BAROSSA ASSESSMENT PANEL

AGENDA

6.1 24012554 - Lot 76 Lindsay Park Road Moculta, 598 Moculta Road Moculta and Lot 281 Moculta Road Moculta

PROPOSAL	Installation and operation of two (2) FrostBoss C49 and two (2) FrostBoss C59 frost fans with Perkins engine
APPLICANT	Treasury Wine Estates Vintners
OWNER	Treasury Wine Estates Vintners
APPLICATION NO	24012554
CERTIFICATE(S) OF TITLE	CT 5131/274, CT 6104/48, CT 6104/49 and CT 5279/98
AREA	213.85 hectares (approximately)
CURRENT USE	Horticulture
PLANNING AND DESIGN CODE VERSION	Version 2024.8 – 9 May 2024
PLANNING AND DESIGN CODE EXTRACT LINK	Relevant Code Extract
ZONE	Rural Zone
OVERLAYS	Character Preservation District (Not In Township) Hazards (Bushfire - Medium Risk) (Medium) Heritage Adjacency Hazards (Flooding - Evidence Required) Limited Land Division Native Vegetation Prescribed Water Resources Area Water Protection Area Water Resources
APPLICATION TYPE	Performance Assessed
PUBLIC NOTIFICATION	Notified – No Sign Required
REFERRALS	Nil
PREVIOUS APPLICATIONS	Lot 76 Lindsay Park Road Moculta 960/5/2018 – Change of Use Agriculture to Viticulture 960/638/2018 – Construction of a 130ML off stream dam (2.3ha surface area, maximum lev

Figure 1 The Frost Control Fan and Receiver Locations

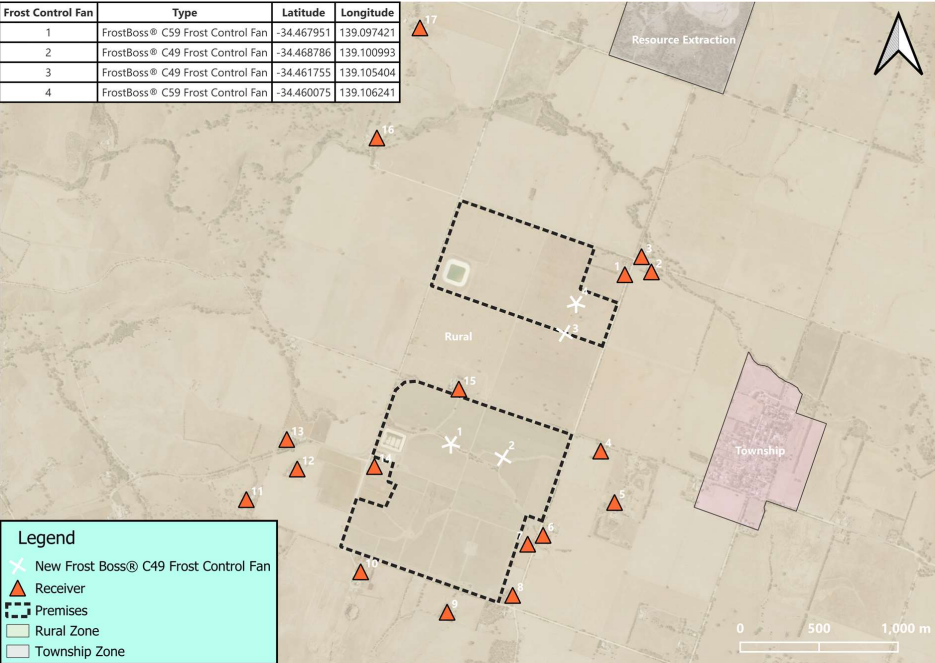
- The location and proximity of the Frost fans is close to our primary place of residence at 787 Lindsay Park Road, Moculta plotted as Sensitive receiver 1. The proposed locations of the fans are 350 metres approx. (MOC 05 Fan C 59) and 370 Metres approx. (MOC 04 Fan C 49) respectively from our family home's rear door. (The plot positions within the report Figure 1 are incorrect as Fan 3 and Fan 4 coordinates are incorrectly labelled with the fan coordinates incorrectly plotted as Fan 3 should read Fan 4 and vice versa). The potential impact on our lives is significant with the Frost fans capable of commencing operation at any time and disturbing the family home and disrupting the current ambience of the location through sound wave pulses and constant noise. The operation of the machines as per the application is within the highest bands of allowable decibel range at nominated 55 LAeq db(A) as per the provided Environmental Noise assessment. The data suggests that the allowable decibel level average of up to 55 LAeq db(A) is acceptable at rural zone and allowable to the sensitive receivers 1, 2 and 3 within the effected impact zone. The predicted noise level at Sensitive receiver 1 is 52 LAeq db(A) but how this level assessment is achieved is not provided and the ability for an analyst to determine a difference of 3 LAeq db(A) is extremely difficult to achieve without an in-field assessment and therefore the findings are challenged. As a result, the determinations of the noise assessment is not considered valid and is therefore not supported.

- The environmental noise assessment does not provide any topographical or in field assessment of the current noise conditions in the area. The cumulative effect of two fans operating simultaneously is mentioned within the assessment but without a defined in-field assessment that cannot be done until installation of the fans its findings are challenged. Essentially should the findings be incorrect once the fans are installed there is no recourse once the considerable expense of installation has been conducted. The elevated position of the Frost fans is of concern as it is predicted that the installation will amplify the sound waves and provide the ability for the sound to reverberate across the terrain as the topography

of the area promotes a funnel effect down the hill towards Duck Pond Creek directly into the impact zone of the Sensitive receivers 1, 2, 3 as per Figure 1.
